**OHIO TURNPIKE AND
INFRASTRUCTURE COMMISSION**

ADDENDUM NO. 1

PROJECT NO. 39-18-02

**PART A - MAINLINE PAVEMENT RECONSTRUCTION, MILEPOST 169.74 TO MILEPOST
176.34, SUMMIT AND CUYAHOGA COUNTIES, OHIO**

689
727

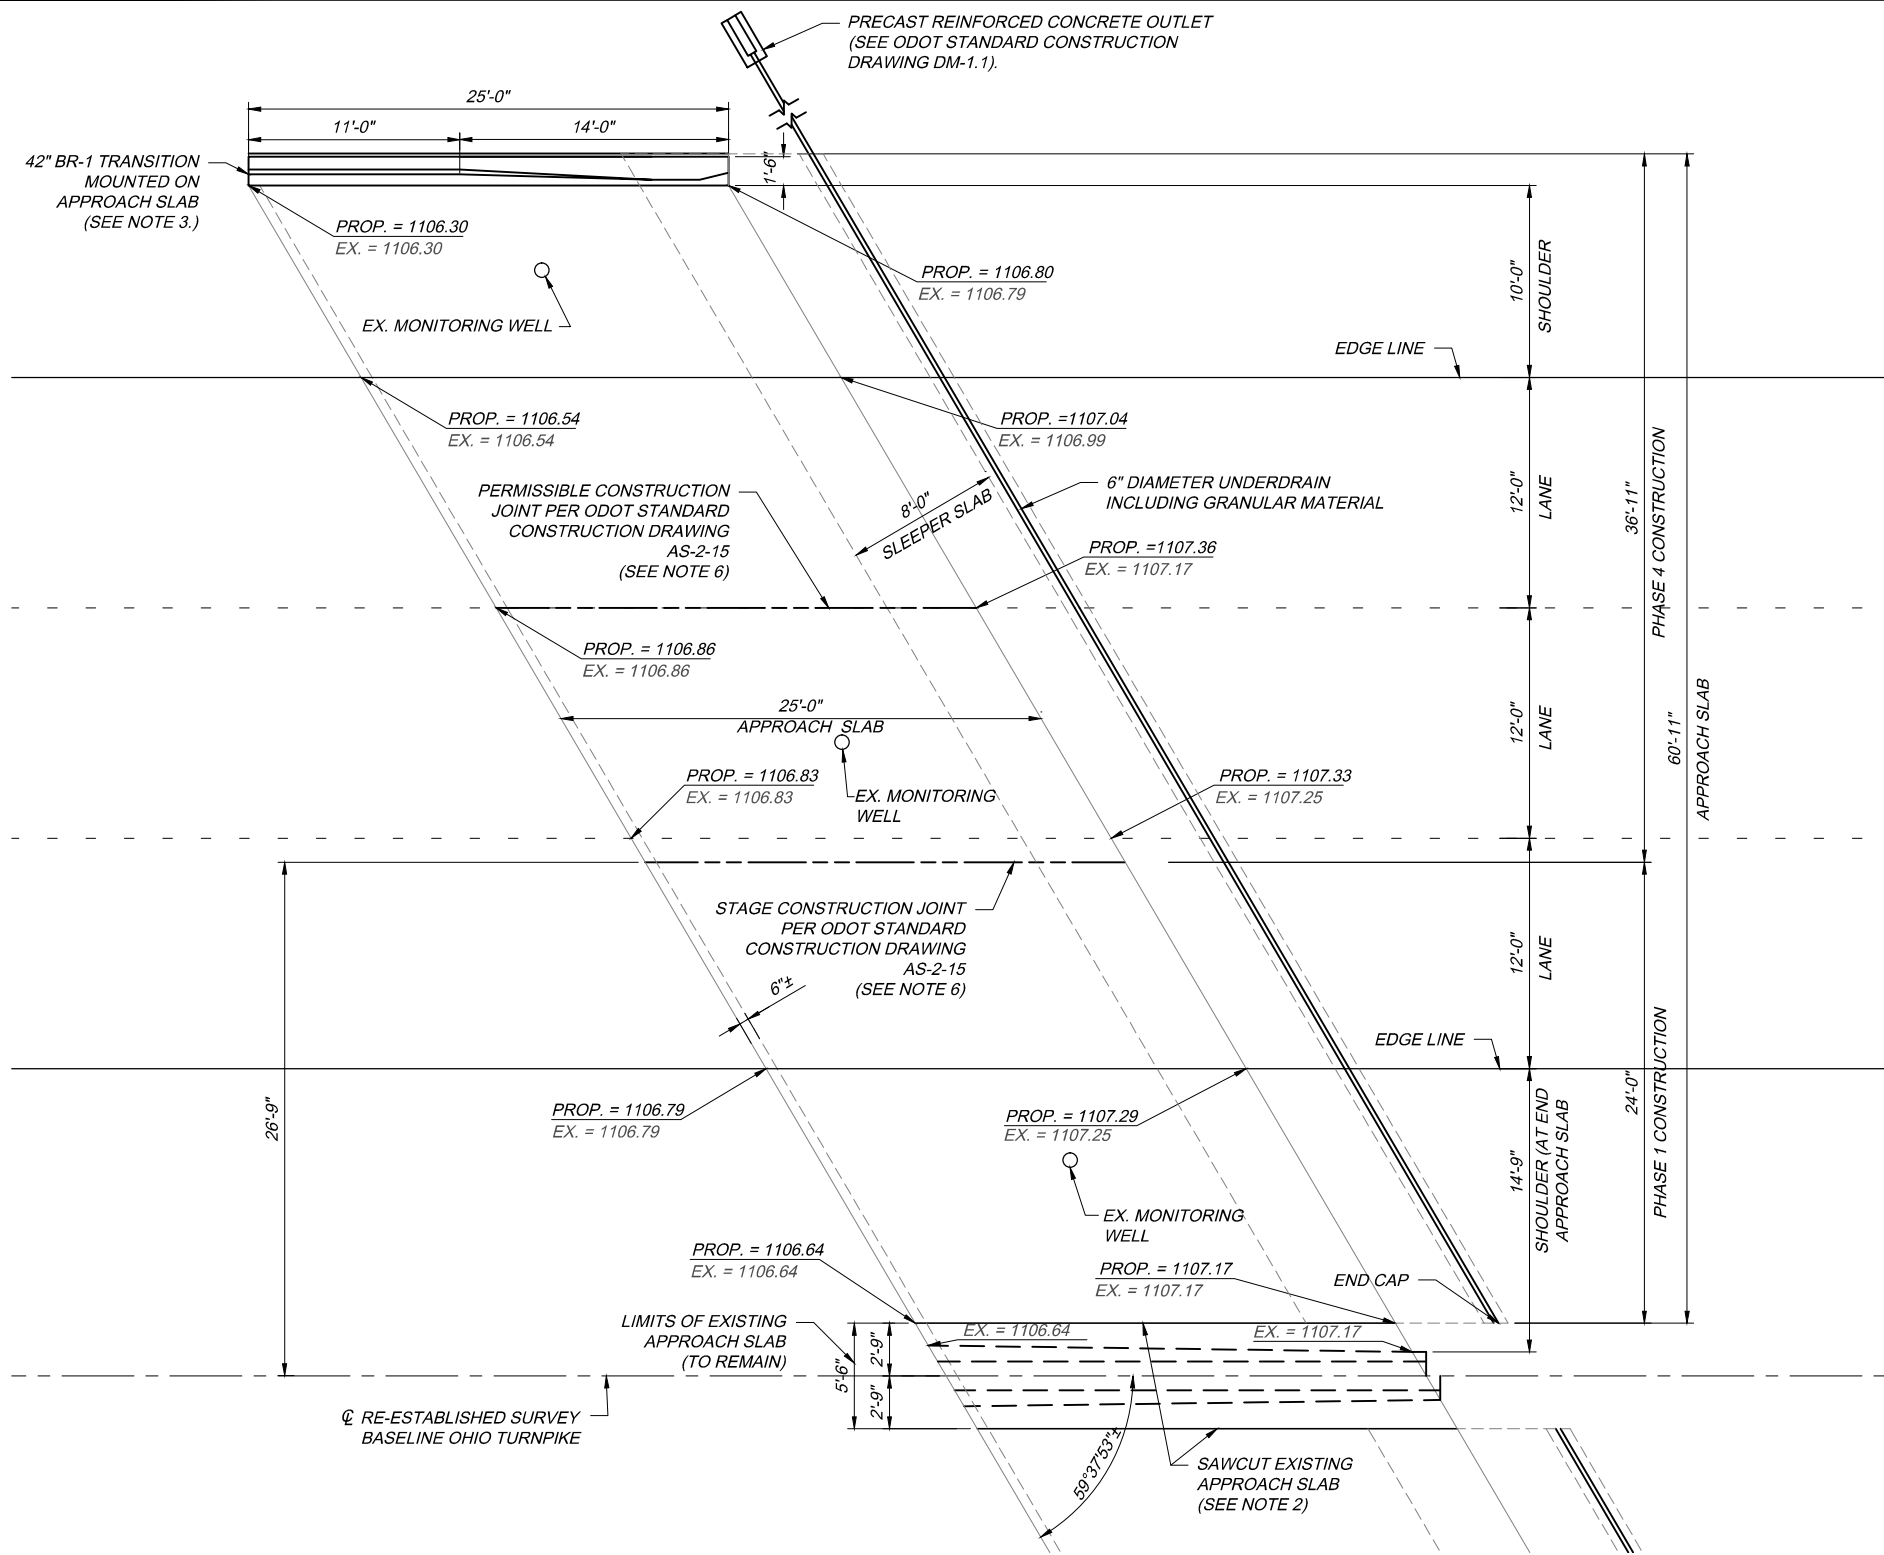
Q#18 Please review the approach slab removed items 13-16 (approach slabs removed types 1 -4) as per plan notes on plan sheet 33 and the notes specifying the type of removal on plan sheets 688-698. None of the removal pay items specified on sheets 688-698 seem to match

the notes on sheet 33 for the work that is required to be completed. Plan sheets 696 & 697 do not specify which item to pay the removal under. Please review the quantities for pay items 13-16 as well and revise as needed.

A#18 This Addendum No. 1 revises the removal pay items specified on Plan Sheet 688 to 698 of 727 to match the notes on Plan Sheet 33 of 727. The quantities for Ref. No. 13 through 16 are correct.

- REMOVAL OF THE EXISTING APPROACH SLAB IS INCLUDED UNDER ITEM 202 - APPROACH SLAB REMOVED TYPE 2, AS PER PLAN. NEW APPROACH SLAB IS INCLUDED UNDER ITEM 526 - REINFORCED CONCRETE APPROACH SLAB, (T=15"), AS PER PLAN.
